SOUTH BAYSIDE SYSTEM AUTHORITY

Subject: South Bayside System Authority Comments on SFBRWQCB Tentative Order (NPDES Permit No. 0038369)

Comments Regarding Tentative Order Dated April 27, 2012 For Reissuance of NPDES Permit No. CA0038369

Plant Process Schematic

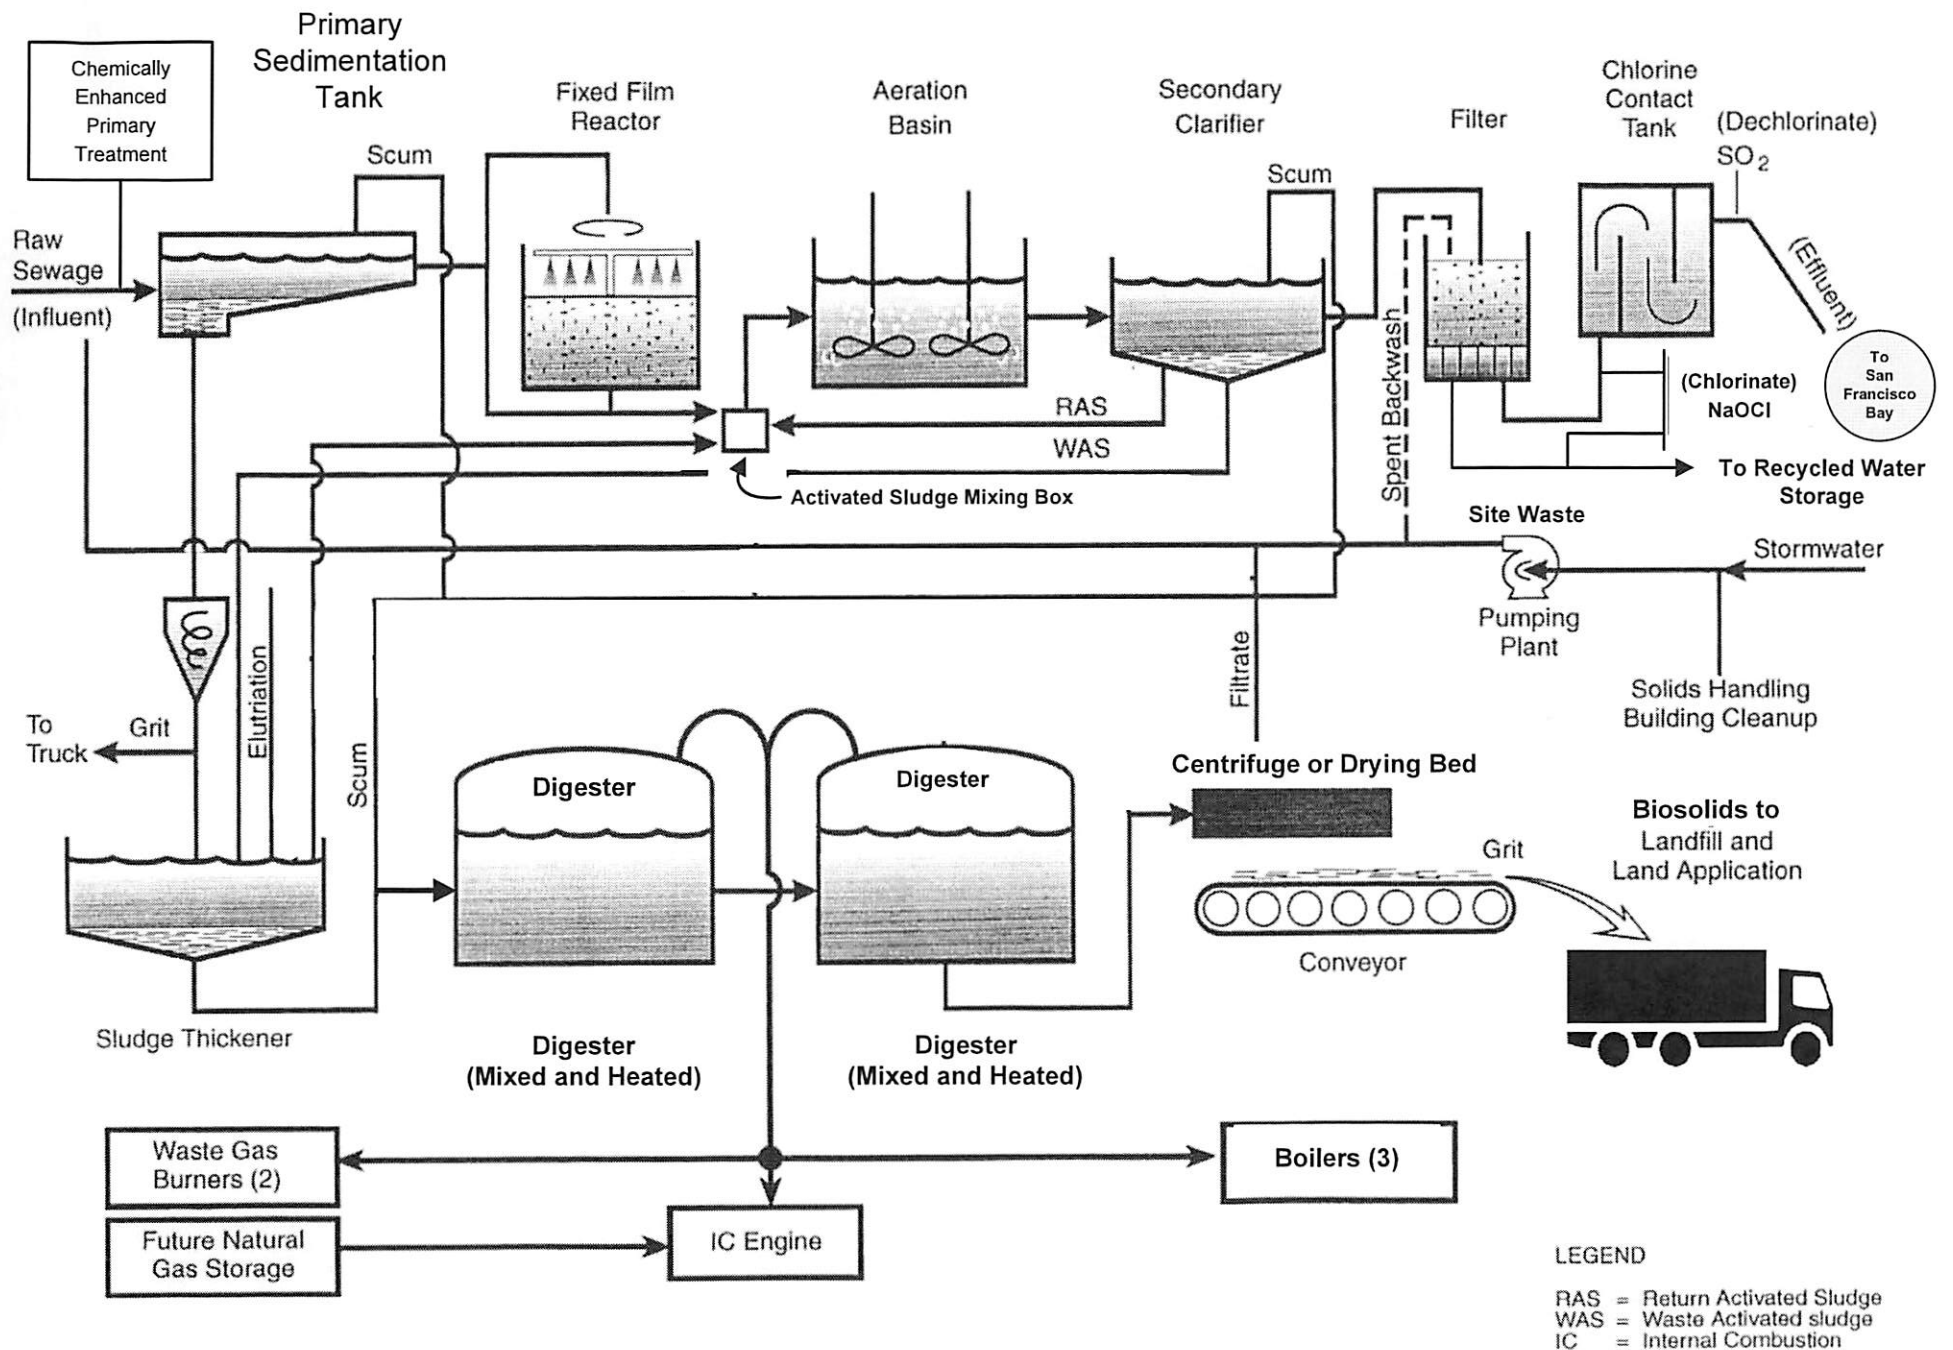
- b. SBSA requests the attached updated Process Flow Diagram be incorporated into the final Order at Attachment C, for consistency with current processes.
